工程指示編號：EI/575/23

工程名稱：將軍澳日出康城

工程項目：佛沙窗 窗玉改方向 現場改 (分判)

工程項目：佛沙窗 大貨 (T1-T3) 改 T1B-D, T2B-D, T3B-D 改方向

J-858, EI/4846改窗方向步驟

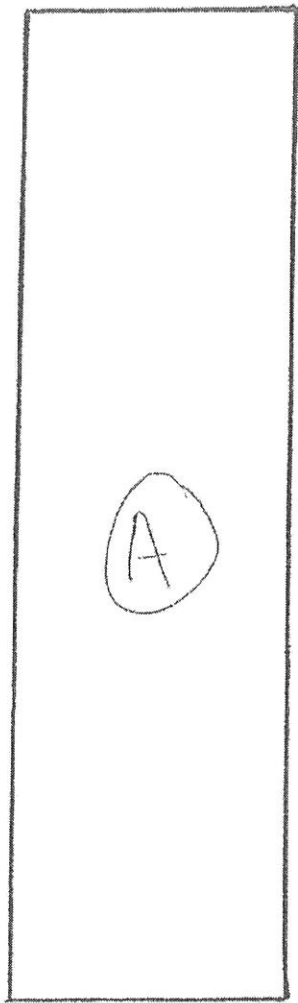
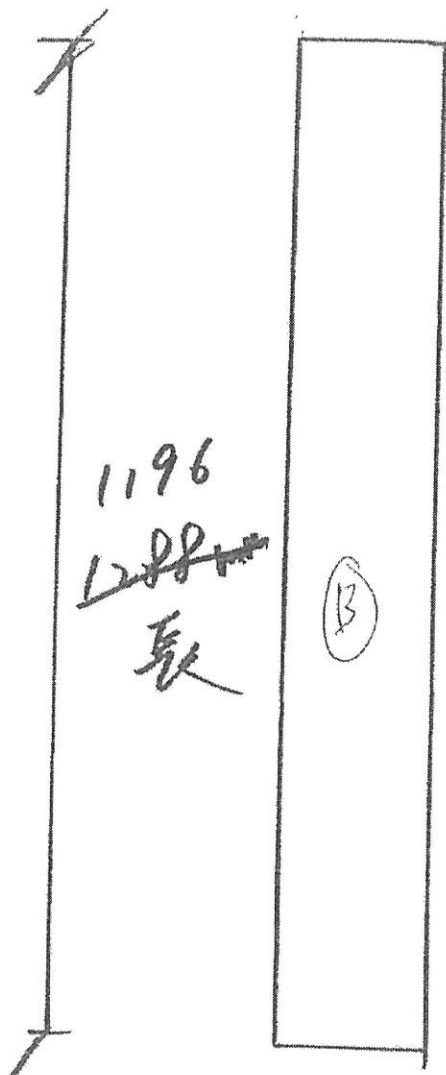
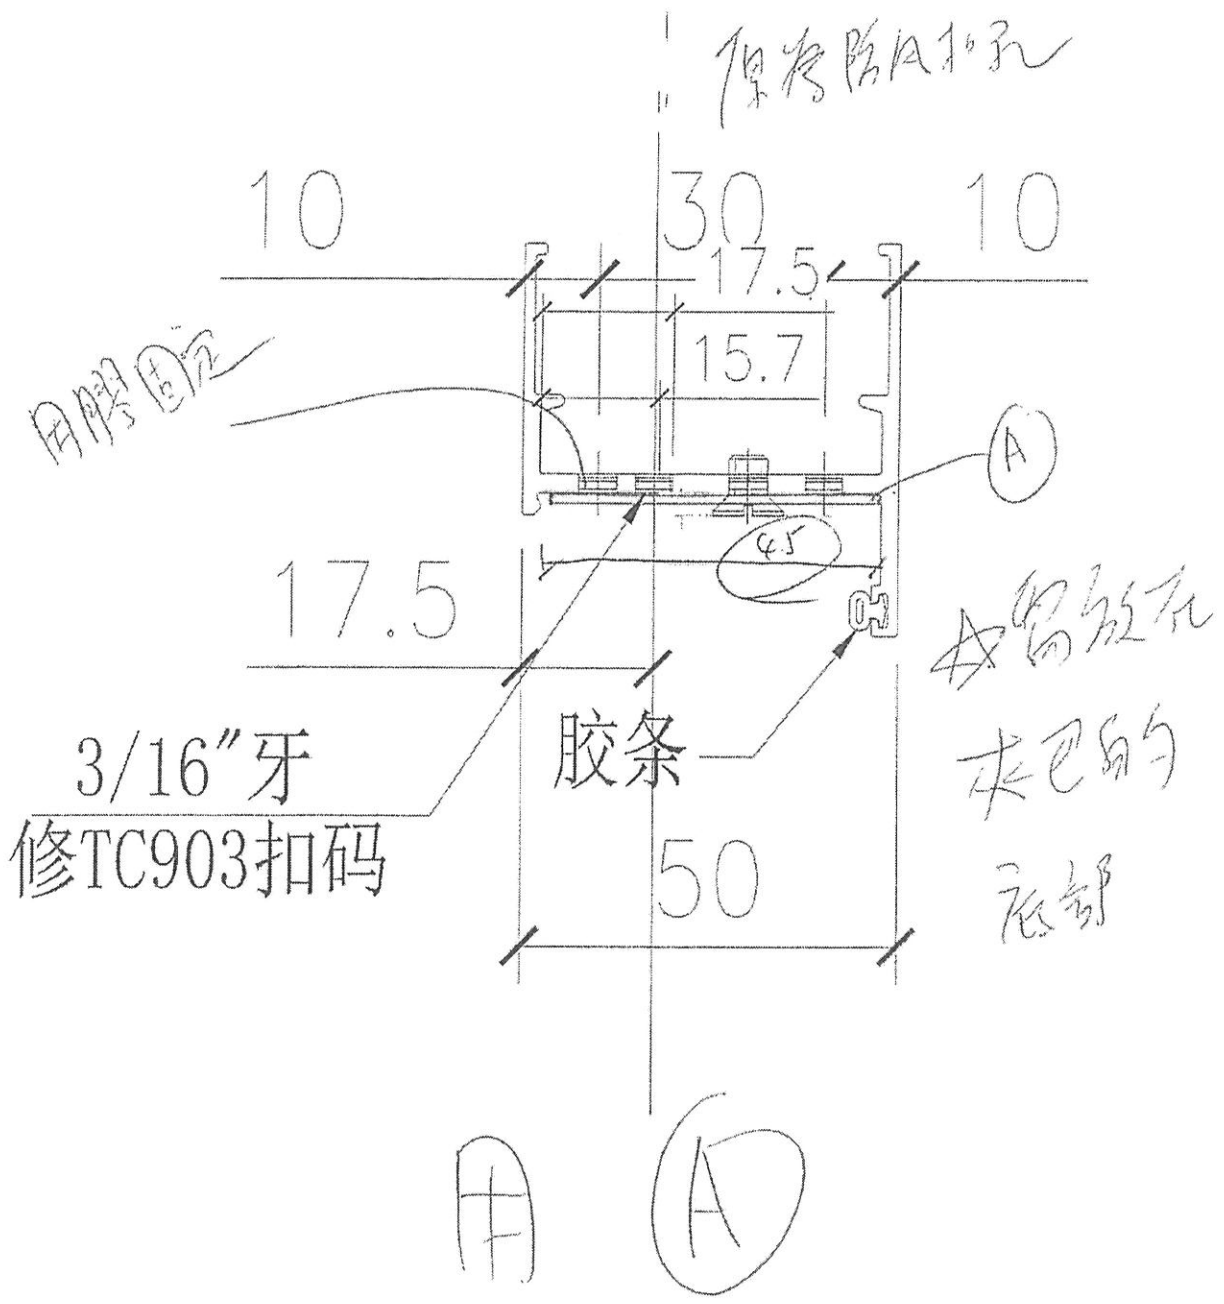
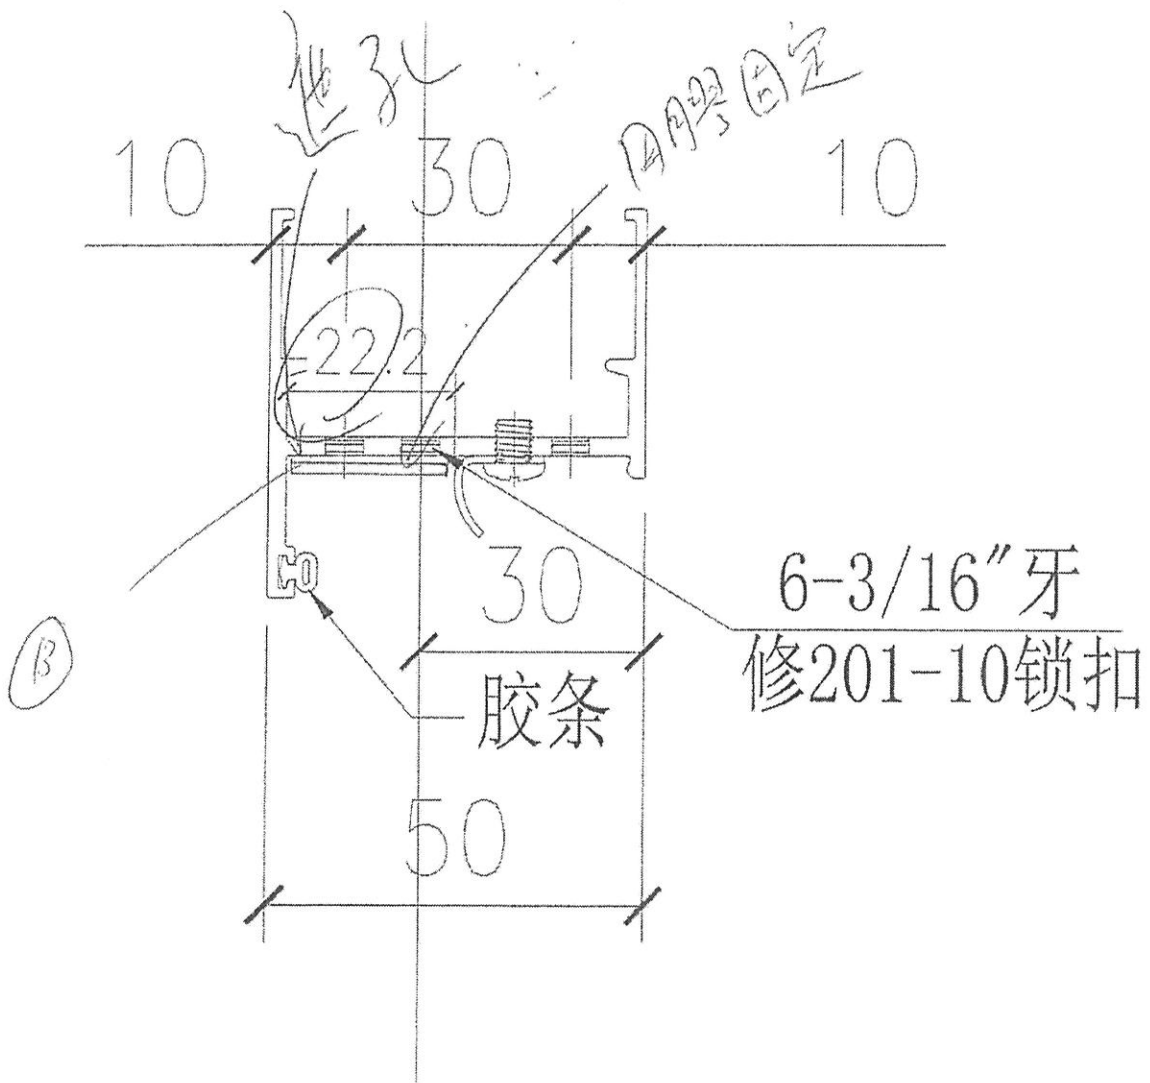
- ① 拆出包裝膠紙
- ② 拆出窗玉及窗玉配件
- ③ 拆出窗框配件及清膠
- ④ 窗框重新鑽扣碼、扇撐、夾叭孔
- ⑤ 重新加工窗玉及玻璃線 (帶手柄一只)
- ⑥ 窗框窗玉組合
- ⑦ 重新包膠紙

美特铝质 有限公司 MIDI Aluminium Fabricator Ltd.	工程號	J858	拆圖	SHAW	2022.02.15
	地盤	康城1期	復核		
名稱	50佛沙窗	顏色	批准

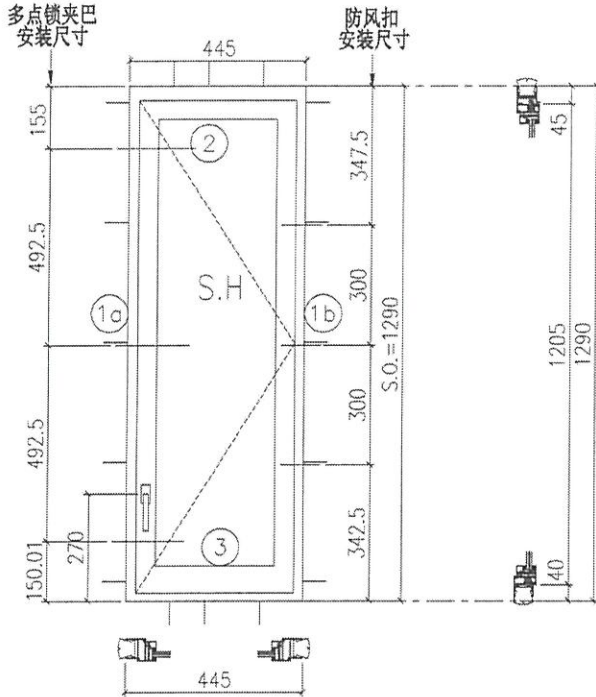
0 版：附上 T1B-D, T2B-D, T3B-D 的改方向後的加工圖，

廠需改 窗玉方向

1. 拆窗玉

2. 改窗框配件(扣碼，扇撐，夾巴孔)

3. 用鋁片遮醜(見附加工圖)，按現場已做樣板

4. 新做窗玉和玻璃線

5. 重新安窗玉
